TECHNICAL SPECIFICATION
FOR
SUBCONTRACT FOR
AREA DEWATERING SYSTEM
FOR THE
CONSUMERS POWER COMPANY
MIDLAND PLANT
MIDLAND MICHIGAN

FACING SHEET
 AREA DEWATERING SYSTEM
 CONSUMERS POWER COMPANY
 MIDLAND POWER PLANT UNITS 1&2
 MIDLAND, MICHIGAN

Cause Investigation and Analysis of Plant Area
Backfill Settlement Problems

Subject: Midland Plant Units 1 and 2
Consumers Power Company
Bechtel Job 7220
50.54(f) September Status Report

BECHTEL
 MIDLAND POWER PLANT
 7770 FIGURE 2

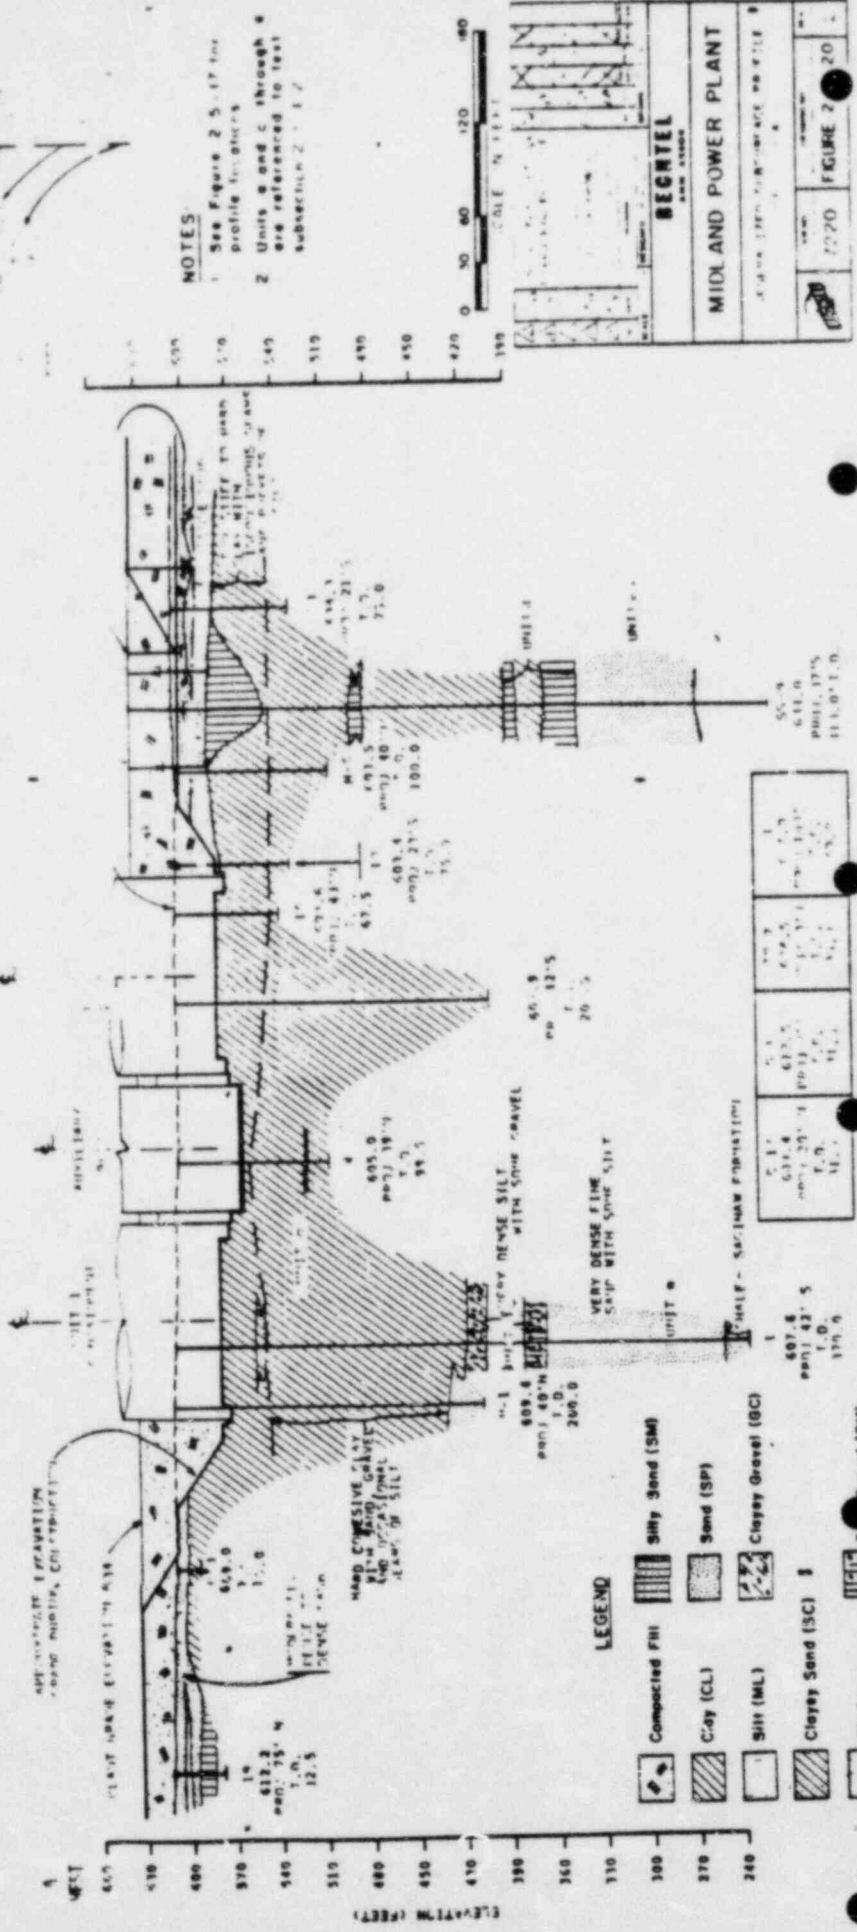
Bechtel Drawing C-44, Note #4 - "Within the excavation area shown all loose surficial sands with relative density less than 75% shall be removed."

Added to this drawing 8/23/75.

*was done
year ago*

Boring logs show us that the soil was not removed, however, it may be greater than 75%.

Vibration + water
